SUBJECT: AMENDMENT NO. 199 TO FACILITY OPERATING LICENSE NO. NPF-3 -
 DAVIS-BESSE NUCLEAR POWER STATION, UNIT NO. 1 (TAC NO. M91557)

TOLEDO EDISON COMPANY
CENTERIOR SERVICE COMPANY
AND
THE CLEVELAND ELECTRIC ILLUMINATING COMPANY
DOCKET NO. 50-346
DAVIS-BESSE NUCLEAR POWER STATION, UNIT NO. 1
AMENDMENT TO FACILITY OPERATING LICENSE

SAFETY EVALUATION BY THE OFFICE OF NUCLEAR REACTOR REGULATION
RELATED TO AMENDMENT NO. 199 TO FACILITY OPERATING LICENSE NO. NPF-3

Figure 3.4-2

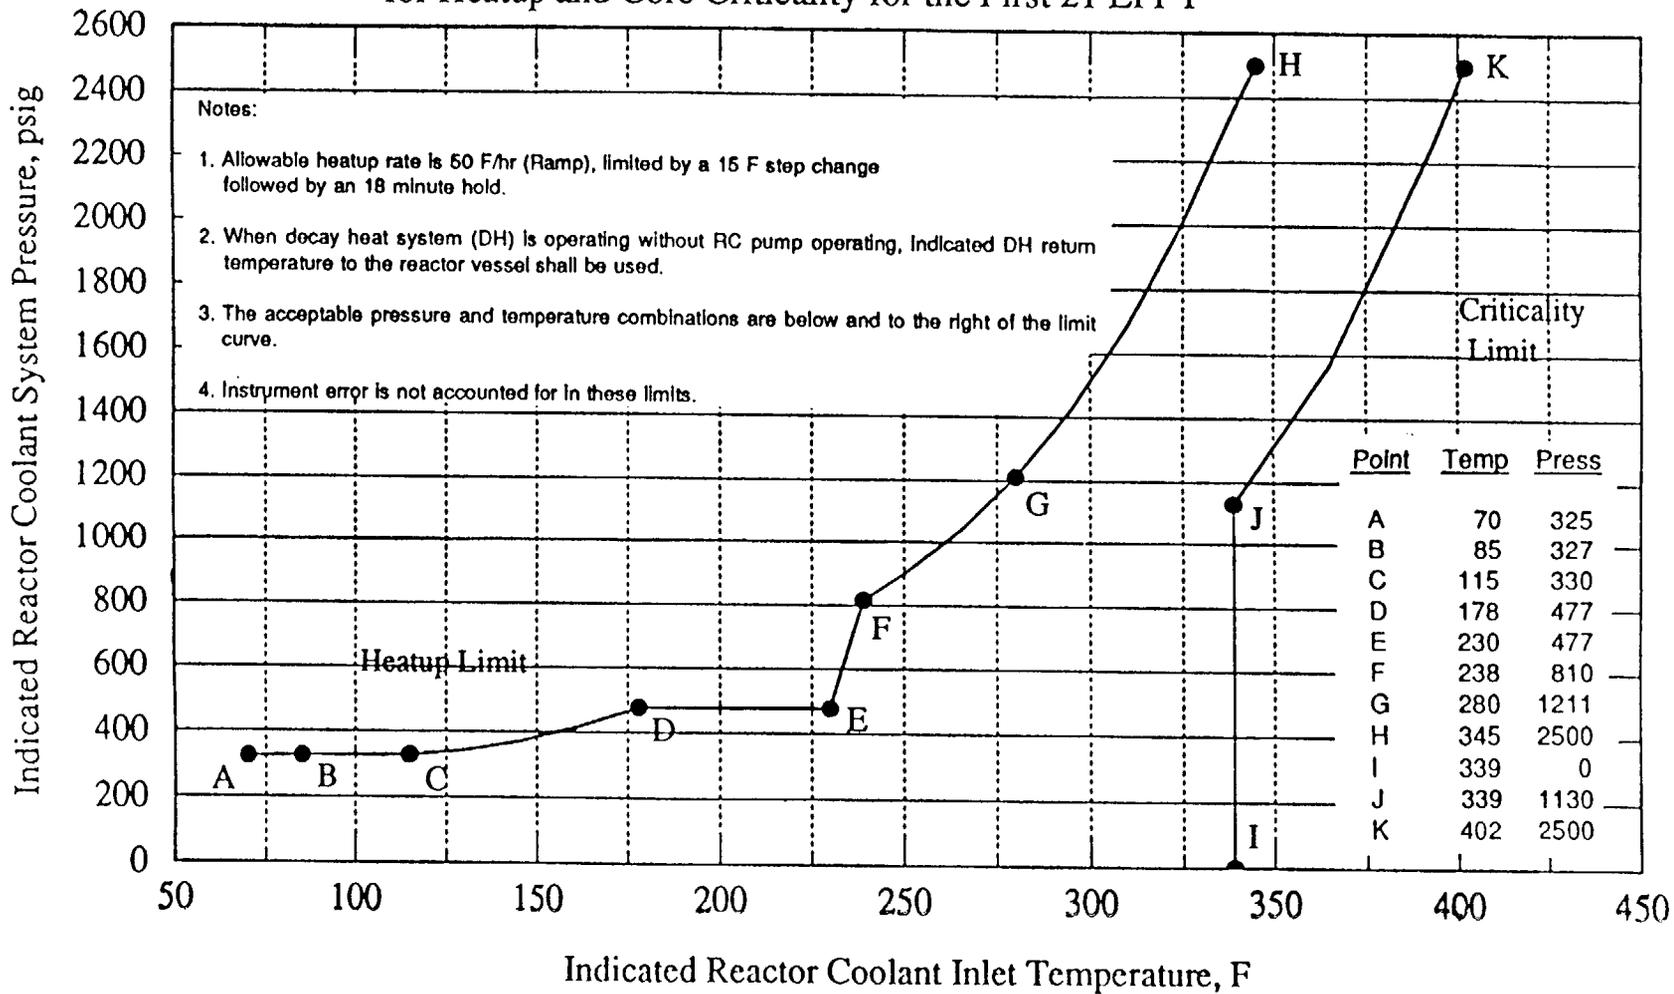
This amendment revises TS 3/4.4.9.1 Pressure-Temperature Limits, Reactor Coolant System (RCS), Figures 3.4-2, 3.4-3, and 3.4-4, Bases Section 3/4.4.9, and License Condition 2.C(3)(d). These TS changes reflect pressure-temperature limits that were analyzed for 21 effective full power years (EFPY) in lieu of the current 10-year EFPY limit.

Figure 3.4-2 presents the pressure-temperature limit curve for normal heatup. This figure also presents the core criticality limits as required by Appendix G to 10 CFR 50. Figure 3.4-3 presents the pressure-temperature limit curve for normal cooldown. Figure 3.4-4 presents the pressure-temperature limit curves for heatup and cooldown for inservice leak and hydrostatic testing.

Reactor Coolant System Pressure-Temperature Limits for Heatup and Core Criticality for the First 21 EFY

Substituting the ARTs into equations in SRP 5.3.2, the staff verified that the proposed P-T limits for heatup, cooldown, criticality, and inservice hydrostatic test satisfy the requirements in Paragraphs IV.A.2 and IV.A.3 of Appendix G of 10 CFR Part 50.
